# Work Order ID 99251

Item Name: Crosstube Aft

DRAWING NO. D412-664-243	TITLE CROSSTUBE ASS'Y (412 HI AFT)	REV. E	<b>DART AEROSPACE LTD ENGINEERING ORDER</b>		D.E.O. NO. D412-664-243-E-2	SHEET NO. SHEET 1 OF 1	SCALE NTS
DRAWN 97	CHECKED AS	MFG. APPR. E	APPROVED MP	DE APPR. H			
DATE 11.09.07	DATE 11.09.19	DATE 11.09.19	DATE 11.09.19	DATE 11.09.19

DRAWING NO. D412-664-243	TITLE CROSSTUBE ASSEMBLY (412 HI AFT)	REV. E	DART AEROSPACE LTD ENGINEERING ORDER		D.E.O. NO. D412-664-243-E-4	SHEET NO. SHEET 1 OF 3	SCALE NTS
DRAWN 90	CHECKED A	MFG. APPR. A	APPROVED MP		DE APPR. MP		
DATE 12.08.21	DATE 12.08.30	DATE 12.08.30	DATE 12/8/30		DATE 12.08-30

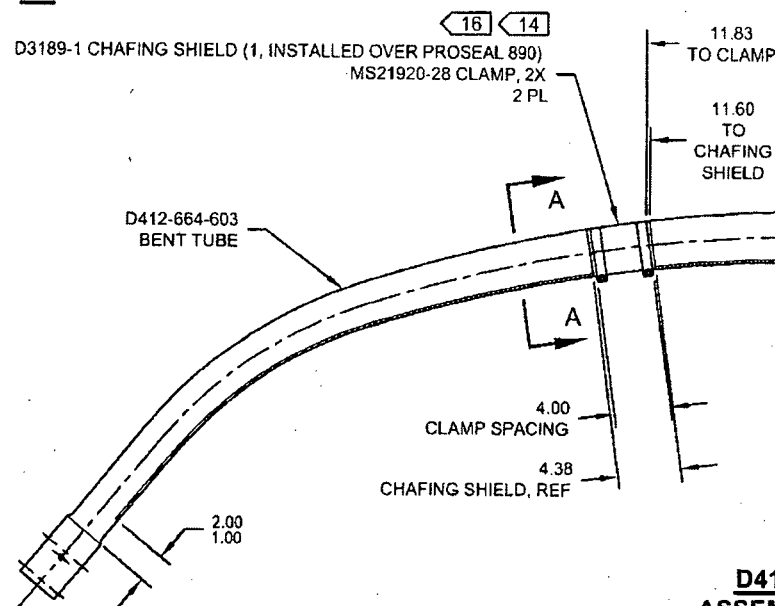
NOTES 2, 14, AND 16 ON SHEET 1 ARE AMENDED AS FOLLOWS:

- 2) FINISH: CHEMICAL CONVERSION COAT PER DART QSI 005 4.1  
PRIME INSIDE AND OUTSIDE PER DART QSI 005 4.2  
MASK UNDERSIDE OF CROSSTUBE AS SHOWN (HATCHED AREA)  
PAINT OUTSIDE PER DART QSI 005 4.2  
AFTER PAINTING, APPLY CLEAR COAT ON HATCHED AREA
- 14) APPLY A THIN COAT OF PROSEAL 890 ON INSIDE CONCAVE SURFACE OF D3189-1 CHAFING SHIELD AND LET CURE PER MANUFACTURER'S INSTRUCTIONS. INSTALL PROSEALED D3189-1 CHAFING SHIELD ONTO CROSSTUBE BY APPLYING A THIN COAT OF PROSEAL 890 ONTO CROSSTUBE. BE SURE TO ELIMINATE ANY AIR GAPS.
- 16) TORQUE CLAMPS ON D2896-1 SUPPORT 80 TO 100 IN-LB. **TORQUE CLAMPS ON D3189-1 CHAFING SHIELD 40 TO 50 IN-LB.** ENSURE AT LEAST 1.5 THREADS SHOWING IN SAFETY AND THAT NUT HAS NOT BOTTOMED-OUT AFTER TORQUING.

**WAS:**

- 2) FINISH: CHEMICAL CONVERSION COAT PER DART QSI 005 4.1  
PRIME INSIDE AND OUTSIDE PER DART QSI 005 4.2  
PAINT OUTSIDE PER DART QSI 005 4.2
- 14) INSTALL D2856-600-1009 ABRASION STRIPS WITH A 0.13 REF GAP ON BOTTOM SIDE OF CROSSTUBE PER QSI 035.
- 16) TORQUE CLAMPS 80 TO 100 IN-LB. ENSURE AT LEAST 1.5 THREADS SHOWING IN SAFETY AND THAT NUT HAS NOT BOTTOMED-OUT AFTER TORQUING.

**D412-664-243  
ASSEMBLY DETAIL**

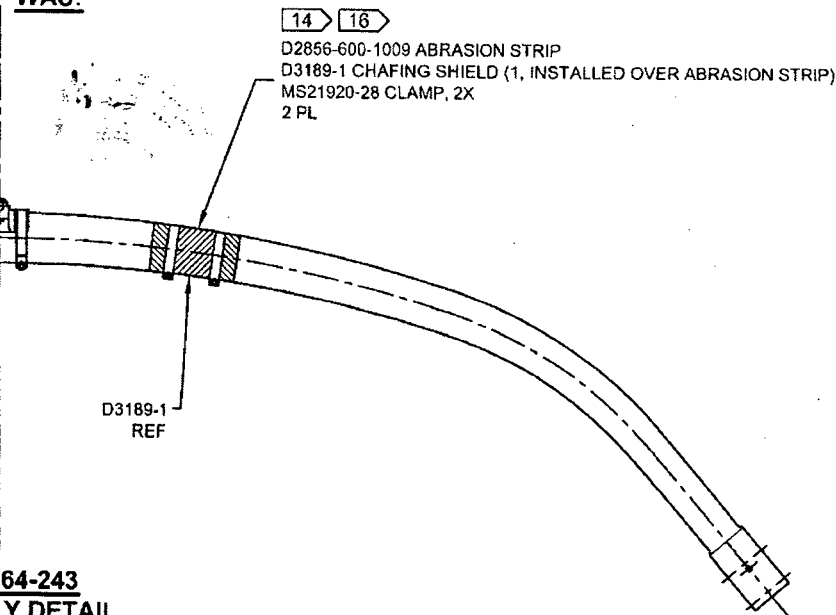
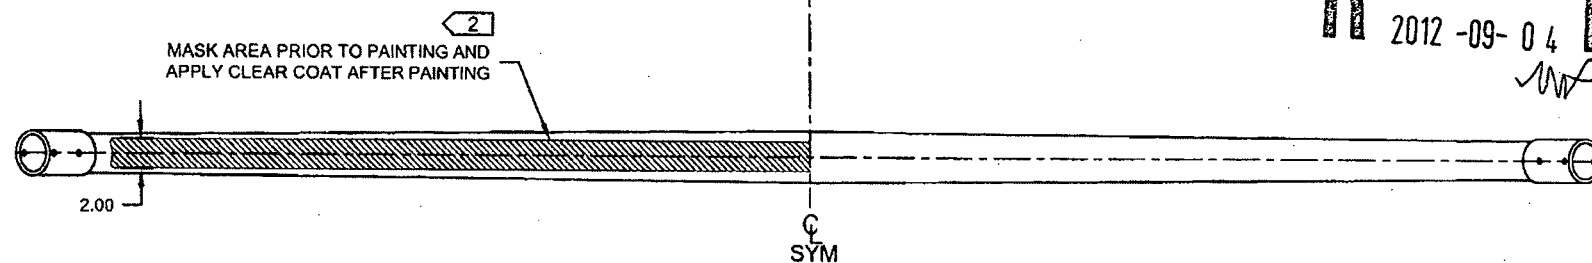
**IS:**

**WAS:**

**SECTION A-A**  
CHAFING SHIELD DETAIL  
VIEW ROTATED, NOT TO SCALE

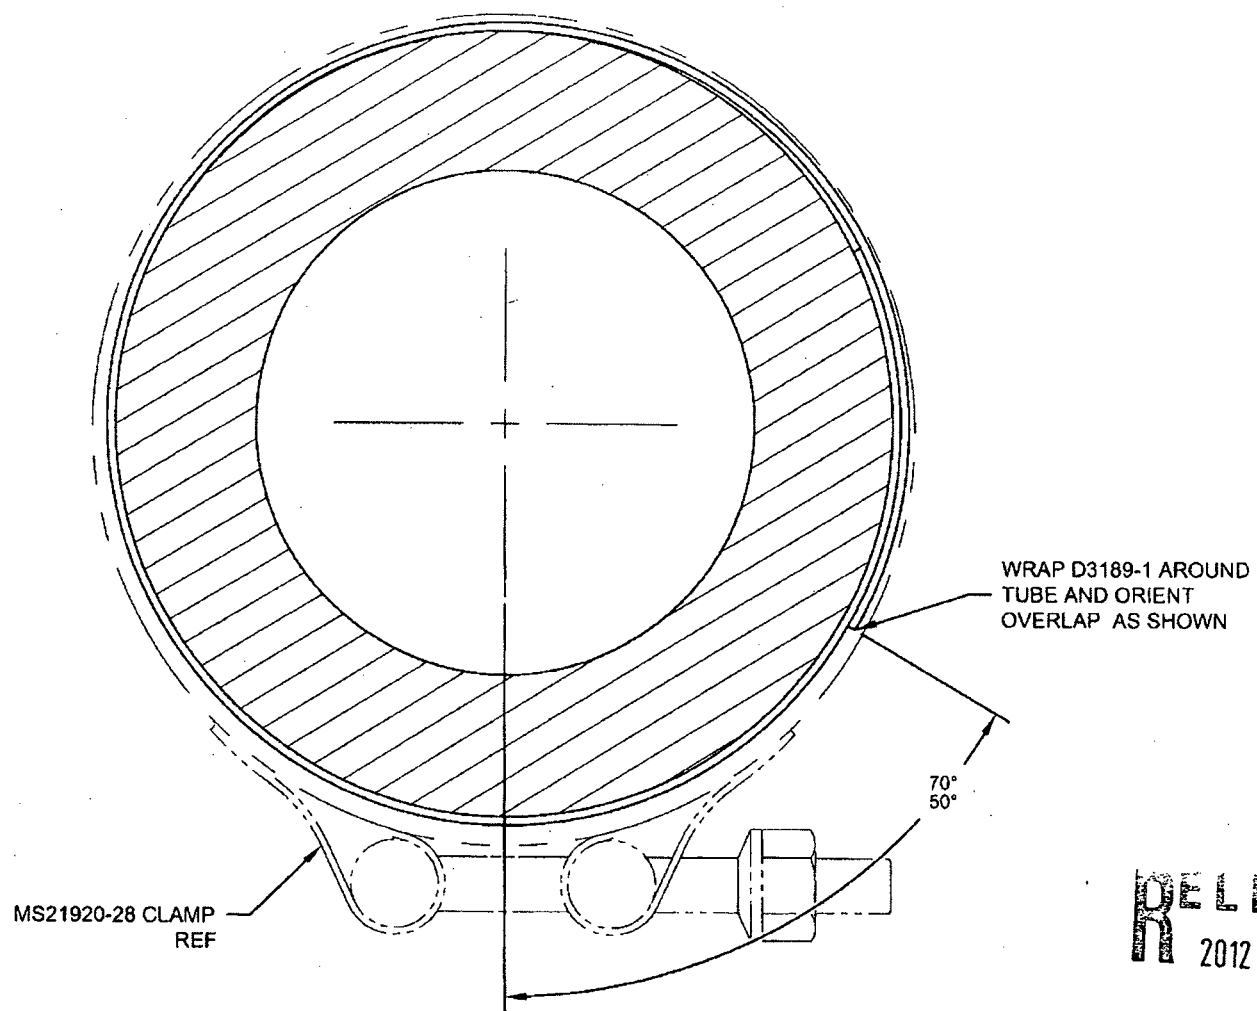
DRAWING NO. D412-664-243	TITLE CROSSTUBE ASSEMBLY (412 HI AFT)	REV. E	DART AEROSPACE LTD ENGINEERING ORDER	D.E.O. NO. D412-664-243-E-4	SHEET NO. SHEET 3 OF 3	SCALE NTS
DRAWN 92	CHECKED	MFG. APPR. <i>M</i>	APPROVED <i>MD</i>	DE APPR. <i>MD</i>		
DATE 12.08.21	DATE 12.08.22	DATE 12.08.29	DATE 12.08.29	DATE 12.08.29	DATE 12.08.29

CRUSHING OF D412-664-243

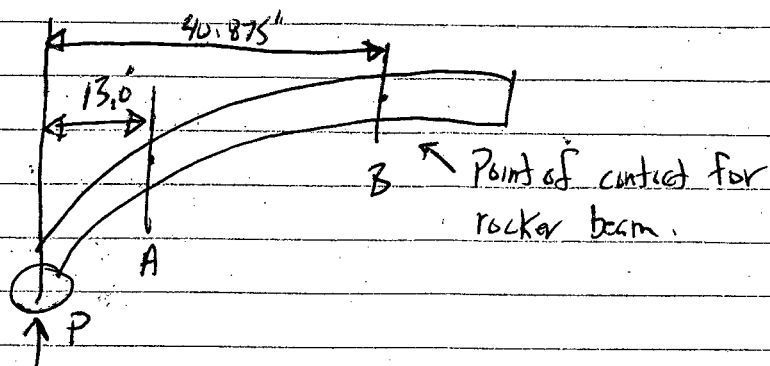
Acceptability of 8% CRUSHING AT END OF BEND

Point A:  $OD_1 = 2.961"$ ,  $OD_2 = 2.522"$
